# PLANNING & ZONING MEETING

City Hall – Council Chamber  
405 Bagshaw Way, Edgewood, Florida  
Monday, January 10, 2022 at 6:30 PM

**2. Special Exception 2021-01 – 1078 Harbour Island Rd  
Accessory Structure/Guest Cottage**

Date: January 4, 2022  
 To: Planning and Zoning Board (P&Z)  
 From: Ellen Hardgrove, City Planning Consultant  
 XC: Sandy Riffle, Deputy City Clerk  
       Bea Meeks, City Clerk  
       Allen Lane, CPH Engineering, City Engineering Consultant  
       Jim Winter, CPH Engineering, City Landscape Architect Consultant  
       Drew Smith, City Attorney  
 Re: Review of Mecatos Bakery and Café Site Plan/Waiver/Variance Application

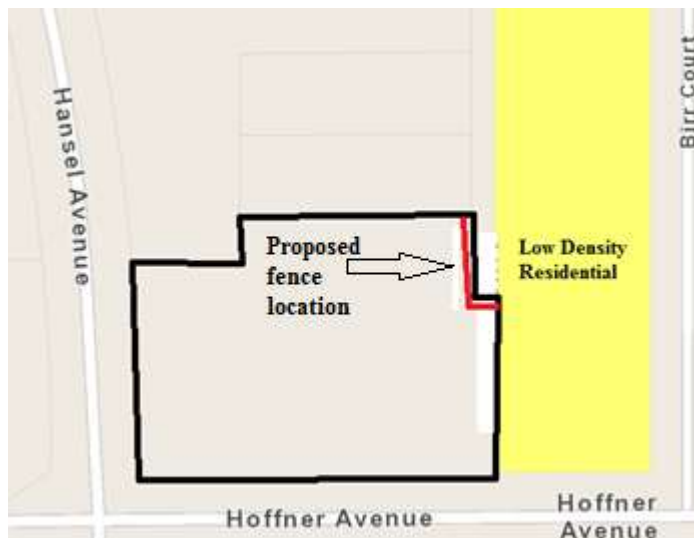
**More information is needed related to retaining the existing light fixture proposed to remain along Hoffner Avenue. The fixture is shown below.**

It may be unreasonable to require jack and bore under Hoffner Avenue to provide electricity to fixtures on this side of the property; however, with other lighting being required to provide the minimum foot candle throughout the parking lot, electricity from a different direction is likely to be available making elimination of this light pole and the overhead wires possible. Additional information is necessary to determine if elimination of this fixture is unreasonable.

The same information is needed for the second existing light pole proposed to be retained. This fixture, which is in the rear/eastern portion of the property, is shown in the photo on the next page. The photo provides a good example for the rationale for meeting the Code standard lighting fixture maximum height and spacing: the light fixture is totally within the tree canopy.

At a minimum the lighting fixture should be replaced to meet the decorative standard and any additional lighting to meet the minimum foot candle along the east side of the parking area should meet the ECD height and decorative standards.

**C-100**

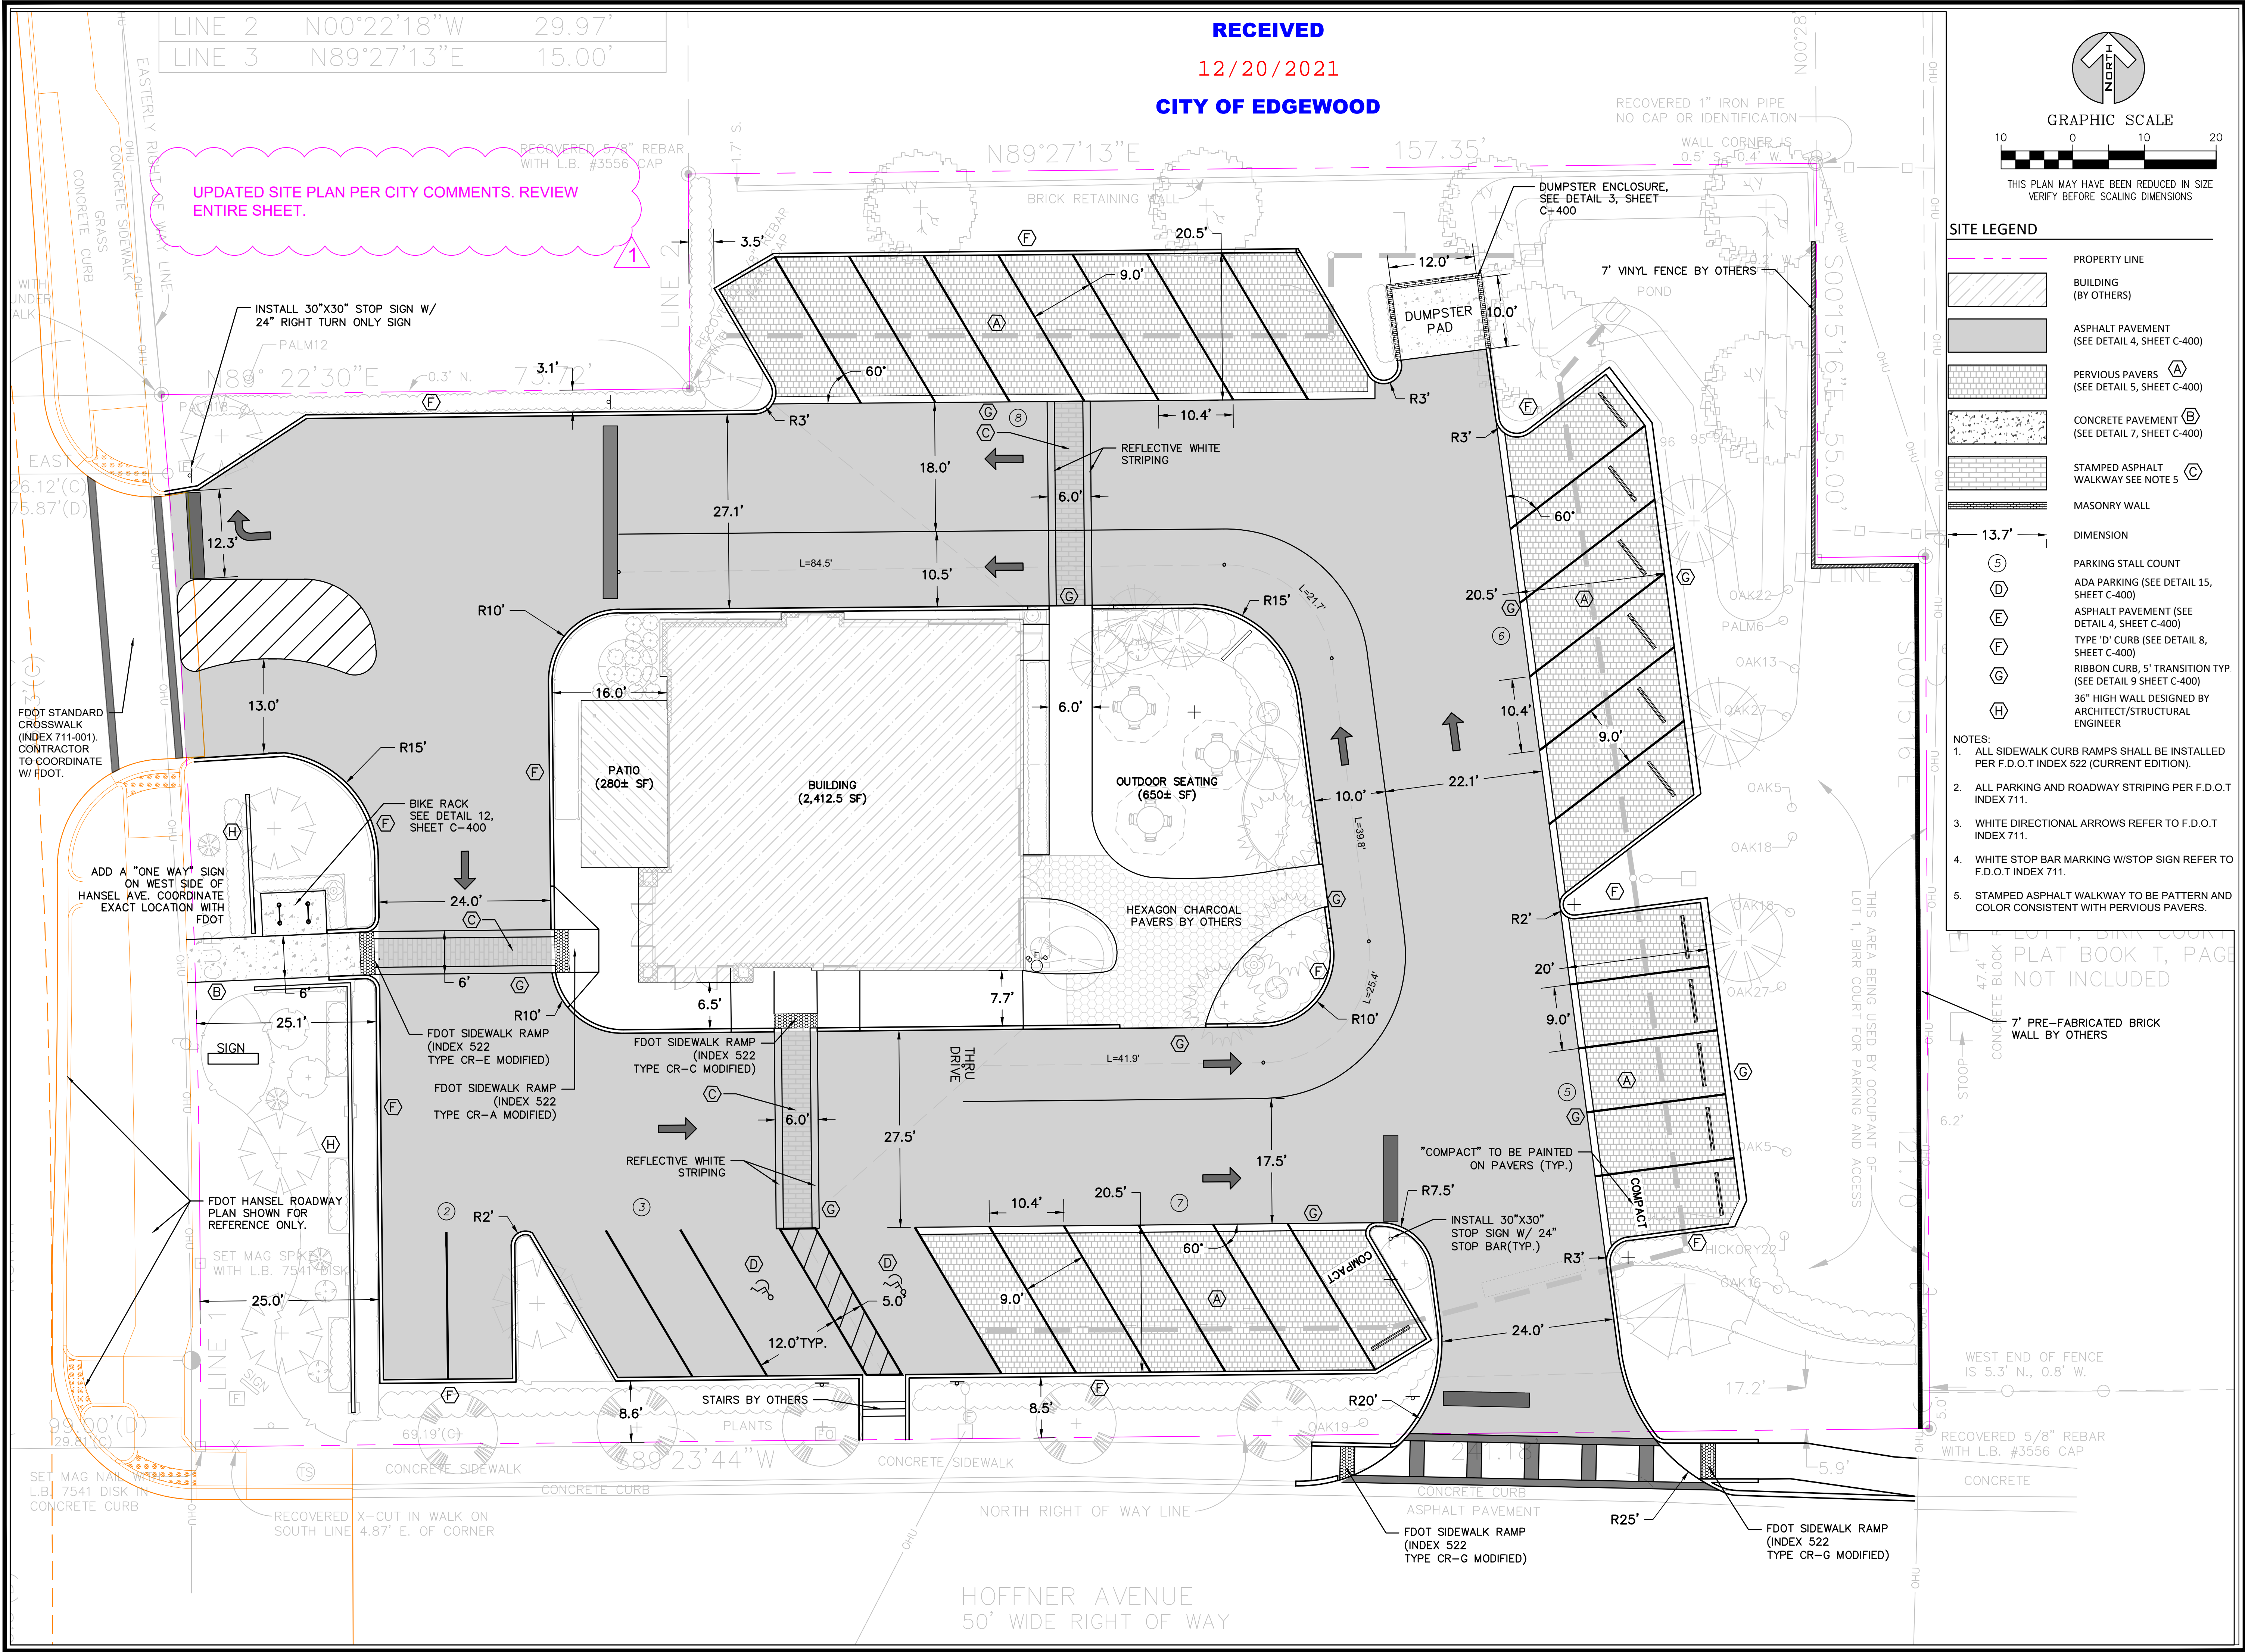
**Request:** **Waiver of Code Section 134-474(c)(4)(a) to allow parking in front of the imaginary line extended from the front building façade. As shown on the site plan, three parking spaces and a fraction of a fourth are in front of the imaginary line extended from the front façade of the building.**

**Request:** **Waiver of Code Sections 134-471(2)e and 134-474(c)(4)a to allow the required street wall on the Hansel Avenue side of the property to be closer than 25 feet from the front property line, thus resulting in less than 25 feet wide of landscaped yard in front of the wall. As proposed, the southern ¾ of the wall is proposed to be located ±21 feet from the property line and the northern ¼ is proposed to be 8 feet from the front property line.**

**Request:** **Waiver of Code Sections 134-471(1)a,134-471(2)i, and Section 134.471(2)e to eliminate the Road View requirements on the Hoffner side of the building;** i.e., a six feet wide impervious area adjacent to the road curb, then an eight feet wide sidewalk, then a 25 feet wide landscaped area extending to the build to line, and a street wall when parking is adjacent to the road

**Request:** **A waiver to Code Section 134-471(2)h, to allow less than fifteen (15) feet wide landscaped islands in parking lots. Such is proposed at the east end of the parking adjacent to Hoffner Avenue and at the west end of the parking along the northern property line.**

**Request:** **Waiver of Code Section 134-470(f) to allow three, potentially non-decorative, light fixtures that are taller than 16 feet. A new 20 feet high light fixture is proposed along the north property line and two 28 feet tall existing light poles are proposed to be retained: one along Hoffner Avenue and one along the parking area east of the building. Illustration of the light fixtures has not been submitted to determine if decorative.**

Waiver of Code Section 134-470(c)(3), which limits height of fences anywhere in the district to a maximum of 48 inches. The applicant is proposing a 6 feet high fence along a portion of the east property line as shown below.

Recommendation: **Staff supports this waiver** and makes a finding that,

Recommendation: **If the waiver for parking in front of the front building elevation is granted, staff supports the southern wall segment location in that it is impractical to place the wall at the required location. If the applicant can demonstrate that there is no other practical location for the bike rack, staff can support the northern segment location.**

**Recommendation:** The Road View/People Space application along Hoffner Avenue was primarily intended for the segment between Orange and Hansel Avenues. Approval of this request is a policy decision: whether this segment of Hoffner Avenue should reflect the ECD design given the ECD will not extend east of this parcel. On other side streets in the ECD, City landscape requirements of Chapter 114 are required. The proposed landscaping meets the Chapter 114 requirements when parking is adjacent to a road: minimum 7 feet wide buffer width, one shade tree for each 40 linear feet, or fraction thereof, and a continuous hedge at least 30 inches high at planting of a species capable of growing to at least 36 inches in height within 18 months, with the height of the hedge measured at grade of the adjacent parking lot.

**Recommendation:** **Staff can support the reduction at the west end of the parking along the**

**Recommendation:** **Non-decorative light fixtures would be contrary to the envisioned ECD is not supported by staff. Additional information is needed related to height.**

Recommendation: **Approval, conditioned on the fence being replaced with a wall consistent with ECD standards along the segment adjacent to the Low Density Residential future land use designated land once the “Brickwood Drive” property is acquired by the subject property’s owner.** Allowing the waiver provides for a logical solution to existing conditions.

NEW ENLARGED SITE PLAN

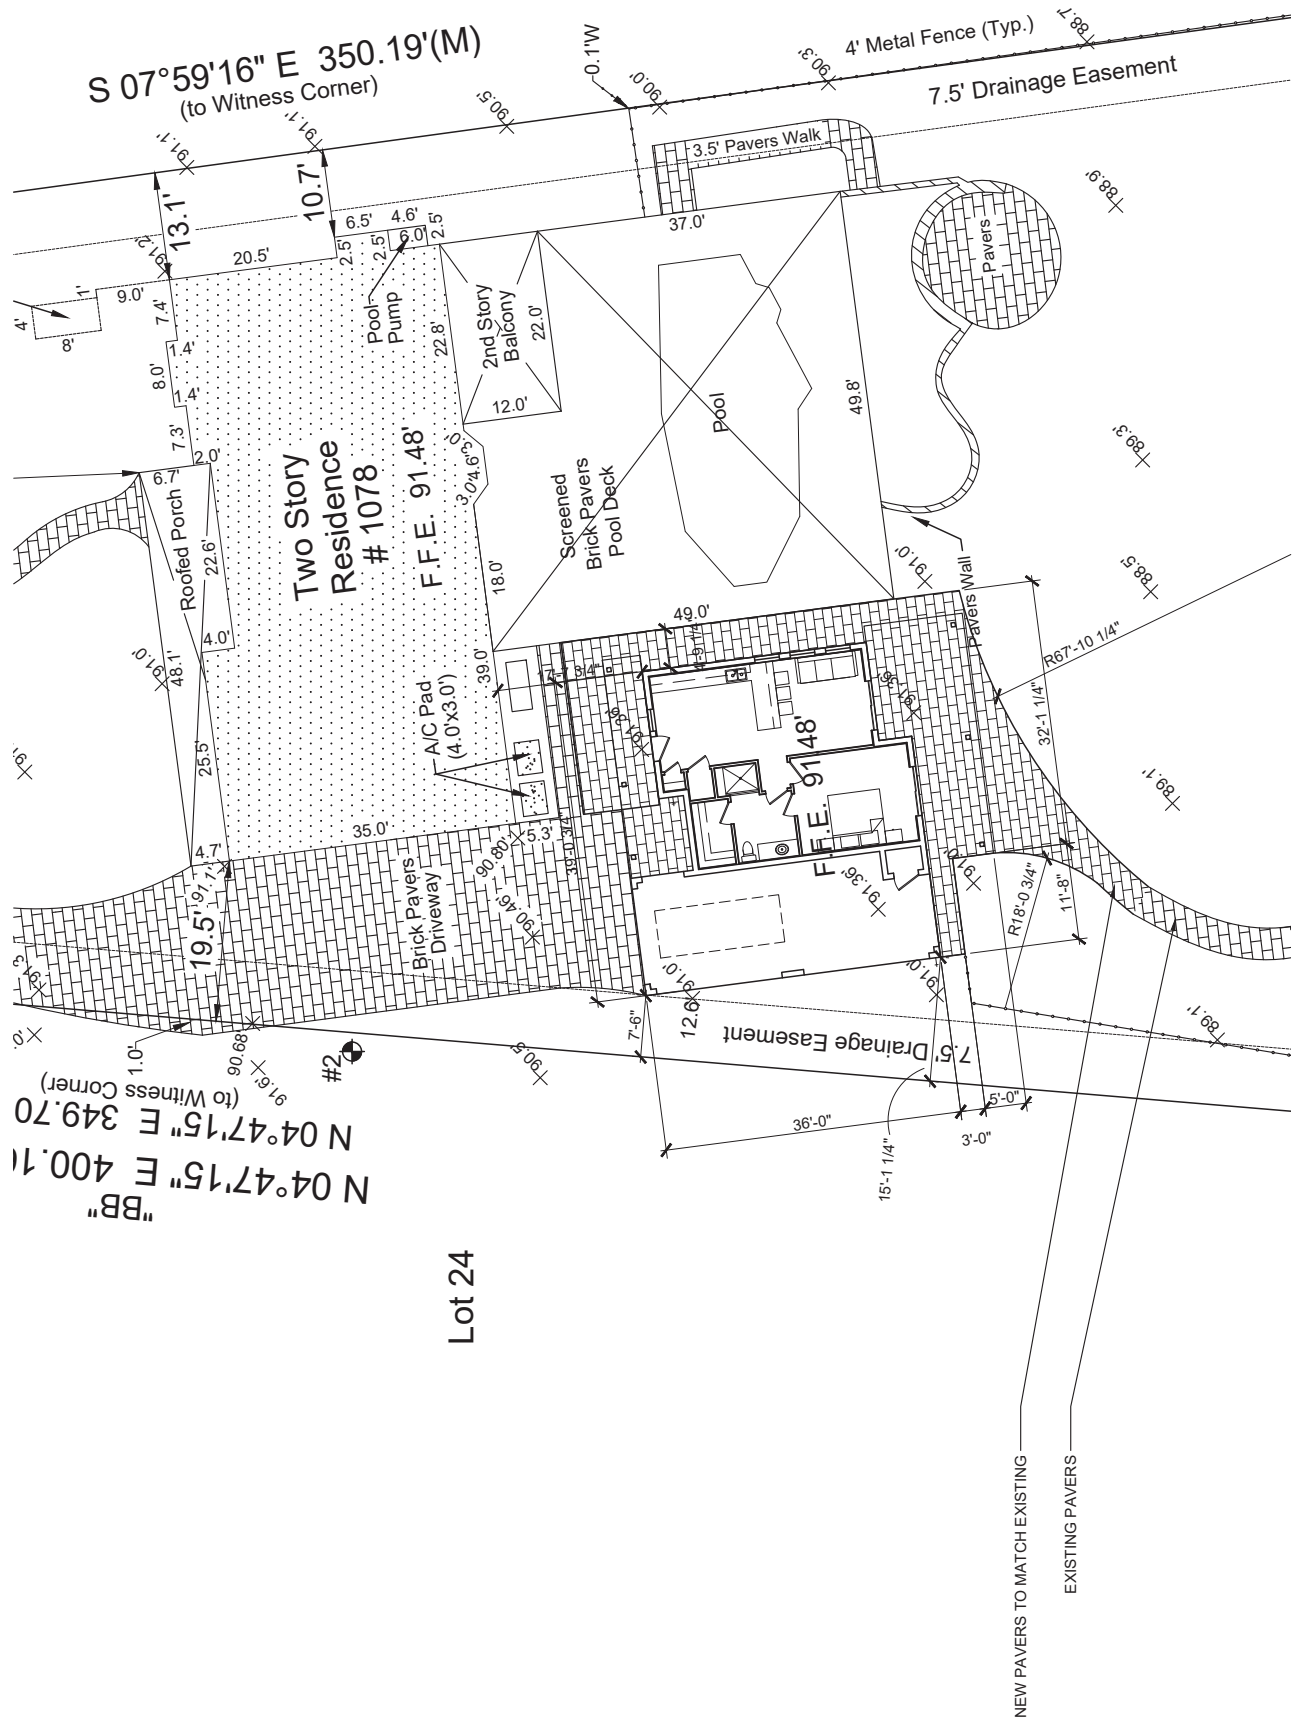
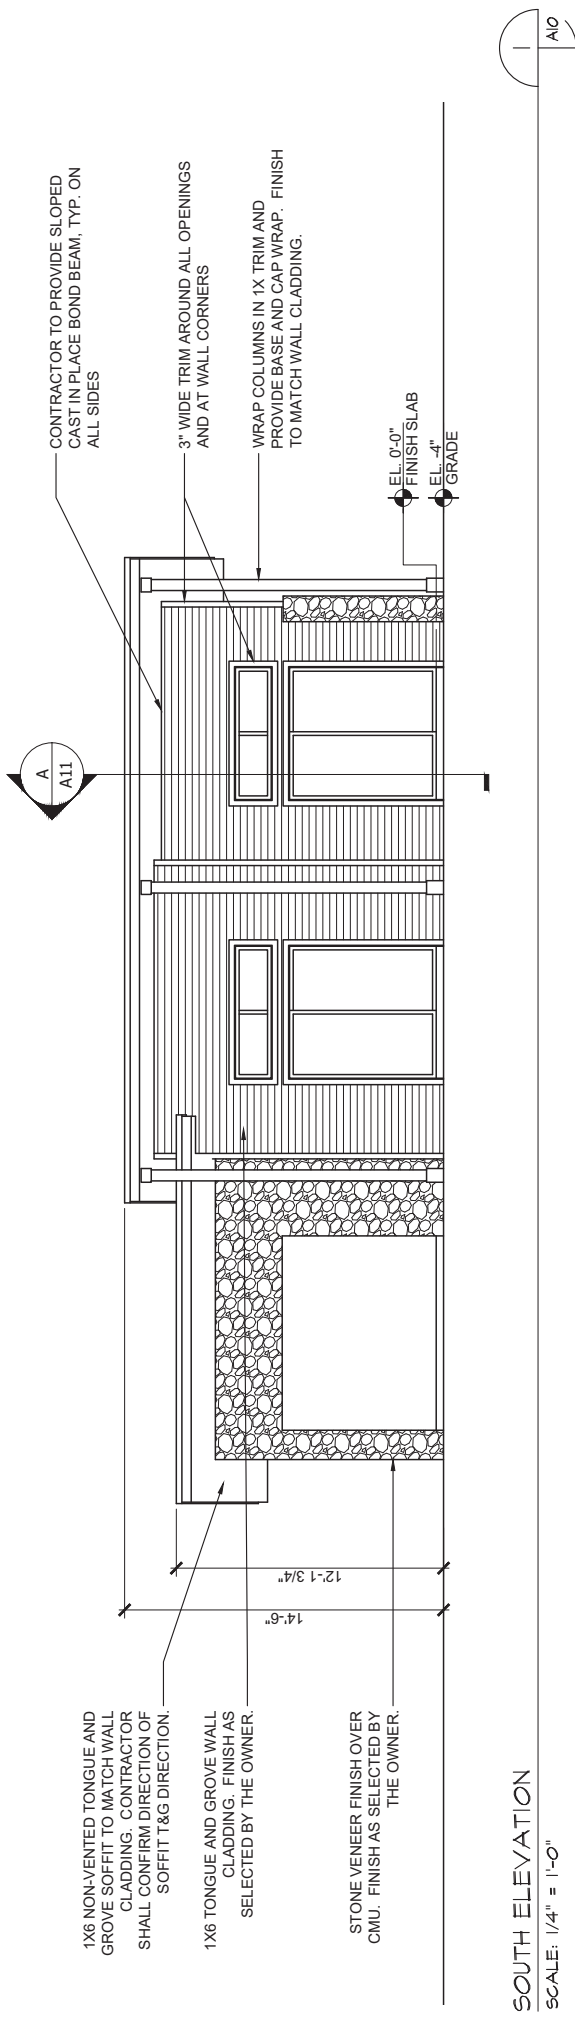
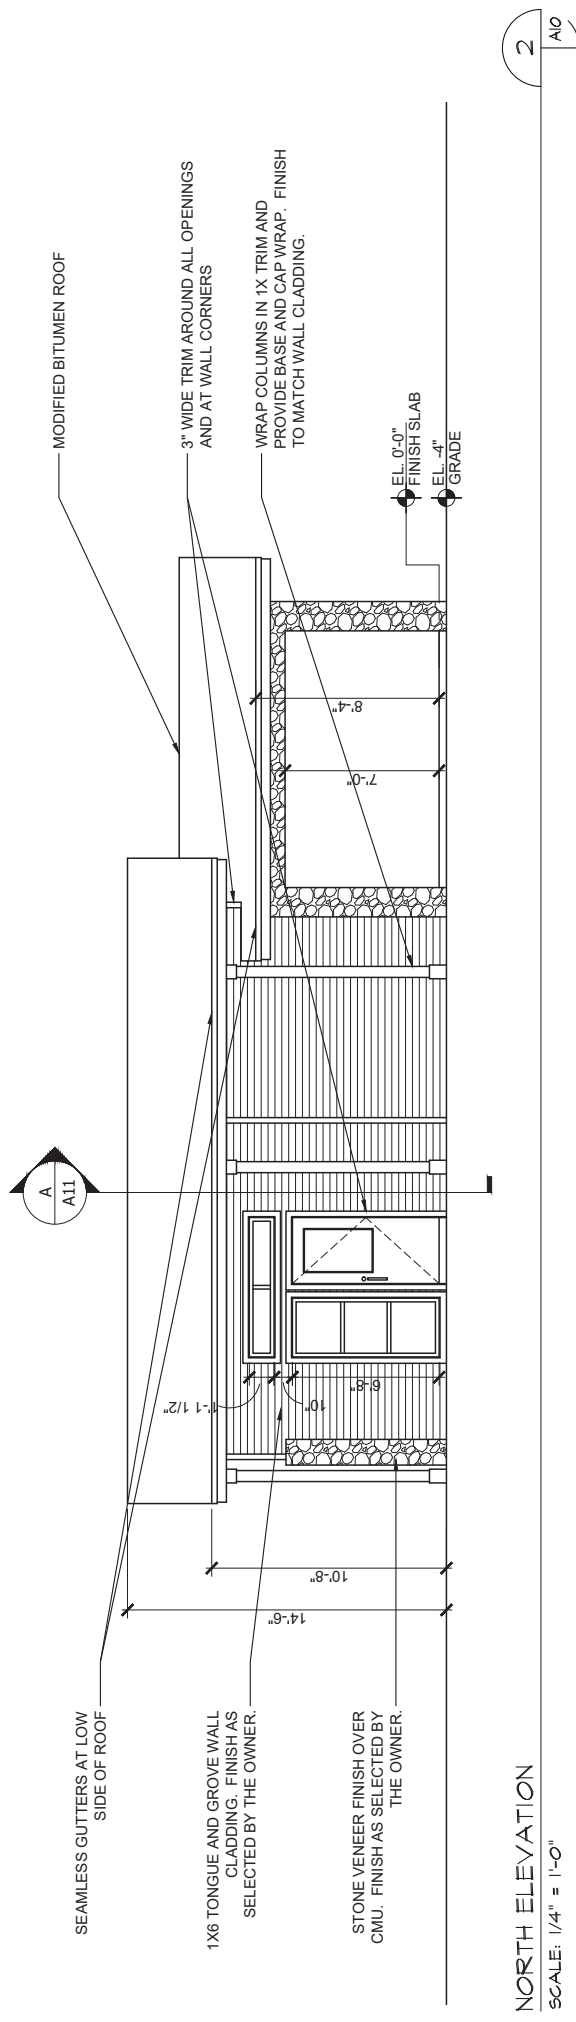
Section 134-483, (i) - The maximum height may not exceed the height of the principal structure. The height is shown on the site plan as 14'-6", which is less than the height of the home and less than the maximum of 16' for accessory structures.

The plans also proposed a 36' by 11'-8" carport. The total area of the car port is 420 SF. Per Section 134-483, (g) – detached garages shall be limited to a maximum of 600 SF.

Based on our review, the proposed accessory structure appears to meet the criteria listed in the City Code. As noted above, the code states this will need to be submitted to the City for review and then to Planning and Zoning and City Council for final approval.
